Kildare County Council

RE: Application for a Declaration of Exempted Development under Section 5 of Planning and Development Act 2000 (as amended) for development at Coláiste Lorcaín, Castledermot, Athy, Co. Kildare.

Declaration of Development & Exempted Development under Section 5 of the Planning and Development Act 2000 (as amended).

ED/1188.

1 **Site Layout Plan**
1:500

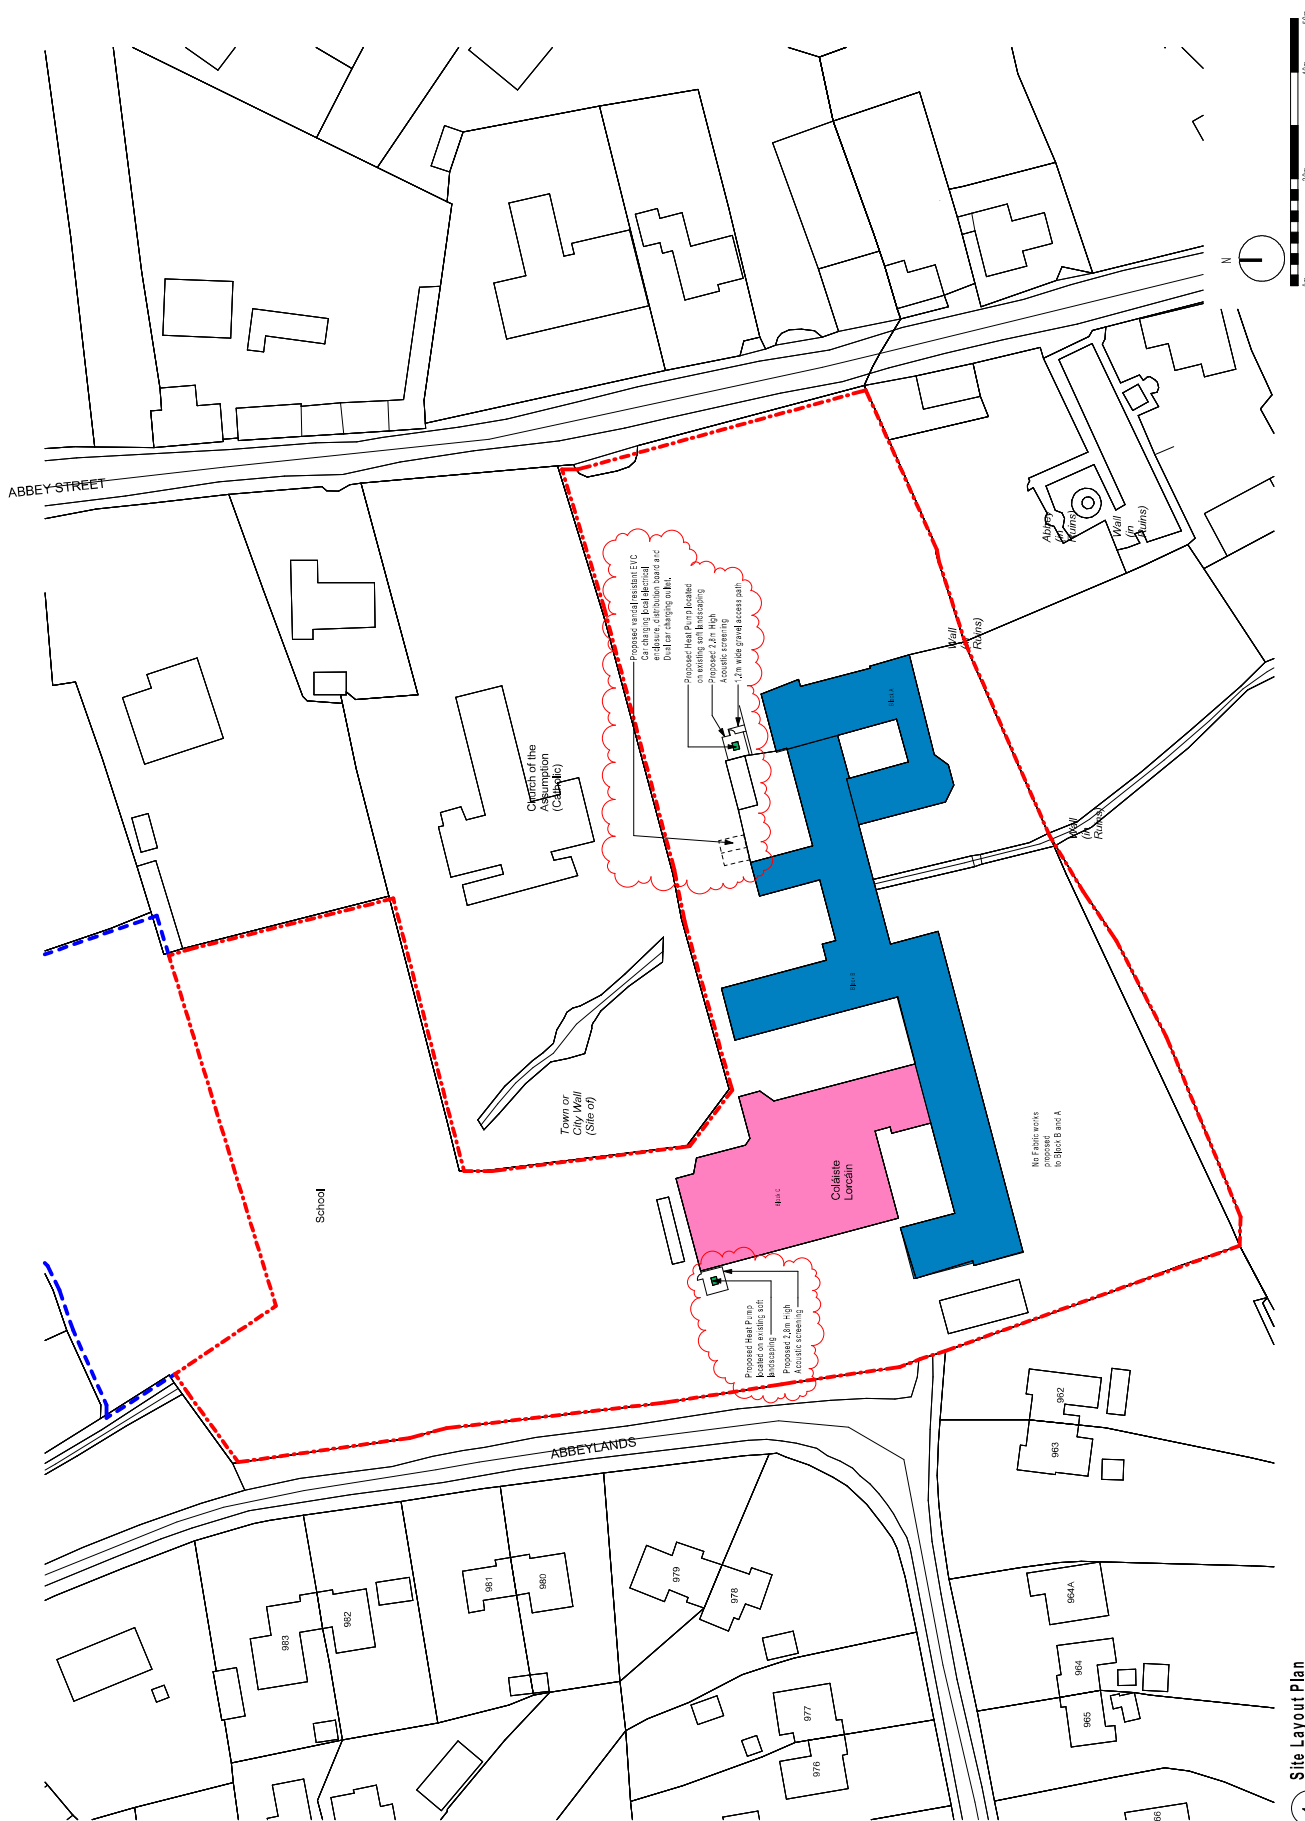
3. Very little detail has been submitted to support the determination for the installation of the air source heat pump. It is noted that no information has been submitted to show either the size, height or length of these items (elevational drawings). For a determination to be made the applicant is requested to submit elevational drawings of these items, with dimensions.

The Site Layout Plan appears to indicate 2x additional items on top of that described in the description which is the subject of this declaration request. A second heat pump to the north of Block A has been outlined and also a vandal resistant EVC car charging local electrical enclosure, distribution board and dual car charging outlet. The Applicant is requested to clarify as to why these items have been included in the site layout plan submitted with the Section 5 Declaration.

4. *The Site Layout Plan appears to indicate 2x additional items on top of that described in the description which is the subject of this declaration request. A second heat pump to the north of Block A has been outlined and also a vandal resistant EVC car charging local electrical enclosure, distribution board and dual car charging outlet. The Applicant is requested to clarify as to why these items have been included in the site layout plan submitted with the Section 5 Declaration.*

3. Very little detail has been submitted to support the determination for the installation of the air source heat pump. No information has been submitted to show either the size, height or length of these items (elevational drawings). Applicant is requested to submit elevational drawings of these items, with dimensions.

4. Site Layout Plan appears to indicate 2x additional items on top of that described in the description which is the subject of this declaration request. A second heat pump to the north of Block A has been outlined and a vandal resistant EVC car charging local electrical enclosure, distribution board and dual car charging outlet. The Applicant is requested to clarify as to why these items have been included in the site layout plan submitted with the Section 5 Declaration.

In response to this point the Applicant submitted a revised site layout plan with details of the 2x proposed air source heat pumps. The first heat pump is located in Block A within an existing service yard which has a 3.1m masonry boundary wall which will screen it from view. The 2nd heat pump is located to the rear of the Block C on existing soft landscaping. This is accessible from the existing footpath around the perimeter of the building. This will have 2.8m high acoustic screening.

In the response submitted the Applicant has stated that the 2nd proposed heat pump and the proposed vandal resistant car charging local electrical enclosure, distribution board and dual car charging outlet are to be considered as part of this Section 5 Declaration. A revised site layout plan has been submitted which amends the red site application boundary previously shown so that these proposed works are now included within it.

BDP Comment: A revised version of the "Site Layout Plan" Drawing is appended to this correspondence which provides greater detail regarding the size, height and length of the 2nr proposed Air Source Heat Pumps as well as their associated enclosures which are located in proximity to Block A and Block C respectively. It can be noted that the ASHP adjacent to Block A is located within an existing service yard which has a 3.1m high masonry boundary wall which will conceal the visibility of same. The ASHP adjacent to Block C is discretely located to the rear of the Gymnasium on existing soft landscaping which is directly accessible from the existing footpath around the perimeter of the building.

BDP Comment: The 2x additional items noted on top of that described in the application form description (i.e. second heat pump to the north of Block A and the vandal resistant EVC car charging local electrical enclosure, distribution board and dual car charging outlet) are to be considered as part of this Section 5 Declaration. It can be confirmed that these items are located within the Site Application Boundary.

Please refer to Drawing: "07CLR-BDP-XX-XX-PL-A-PP0002 (REV_P03)"
